PRODUCT CHANGE NOTIFICATION

Bourns® SRF1260 and SRF1280 Series Dual-Winding Shielded Power Inductors

Assembly, Process and Gluing Changes

IC25029

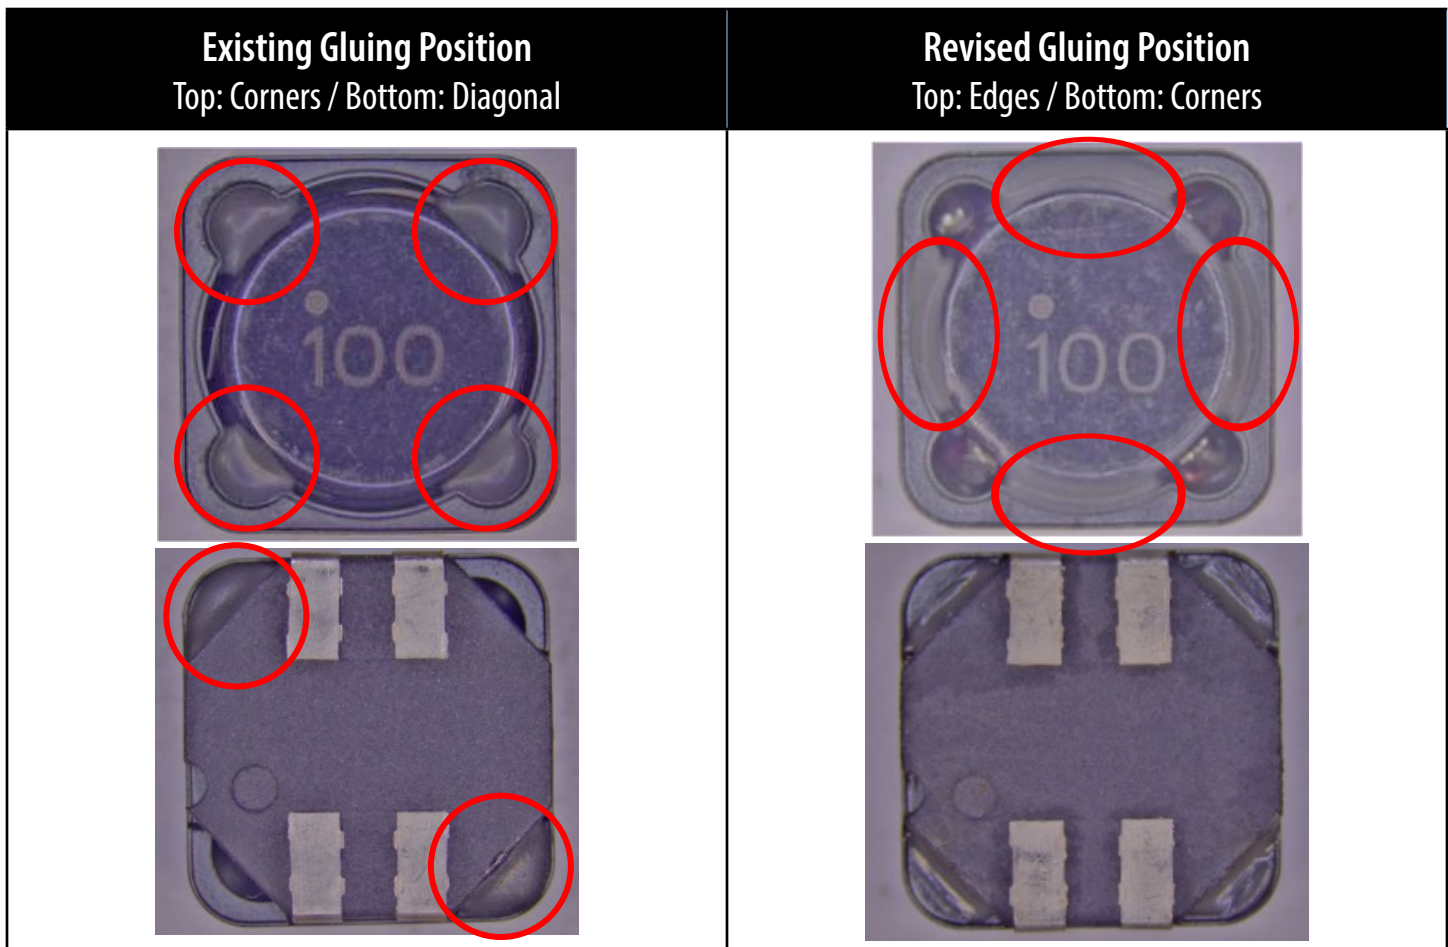
Riverside, California –March 18, 2025 – In the spirit of continuous improvement, effective September 29, 2025, Bourns will change its assembling and gluing processes from manual to automated for the [SRF1260](#) and [SRF1280](#) Series Dual-Winding Shielded Power Inductors. The type of glue and its application position will also be changed to enhance durability. The new glue supplier has been qualified and is included in the Bourns Authorized Vendor List. Additionally, the copper wire color will be changed from gold and red to gold only. A list of affected part numbers is included below.

As shown in the images above, the form of the affected part numbers will change slightly due to the change in gluing position. The fit and function of the affected inductors will remain the same. The quality and reliability of the affected inductors should be improved as a result of the changes. Traceability will be maintained through lot code and date code.

Date that deliveries of products manufactured using the current assembly, processes and glue will cease: **September 28, 2025**

Date that deliveries of products manufactured using the new assembly, processes, and glue will begin: **September 29, 2025**

First date code using the above changes: **2540**
